**RE: WALNUT AVENUE WATER DISTRIBUTION AND STREET
IMPROVEMENTS**

**WAGNER, SOUTH DAKOTA
SPN #16394**

ADDENDUM NUMBER 1

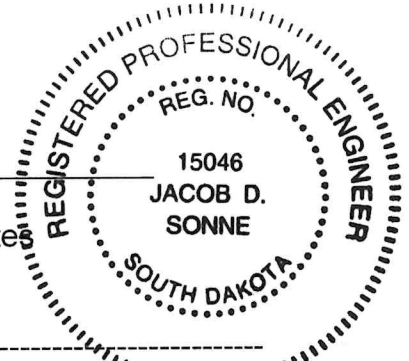
Item 17 "12" PVC Encasement Pipe" was removed and replaced with "14" PVC Encasement Pipe".

The quantity for item 19 "6" PVC Water Main" was adjusted from 35 Ft to 74 Ft.
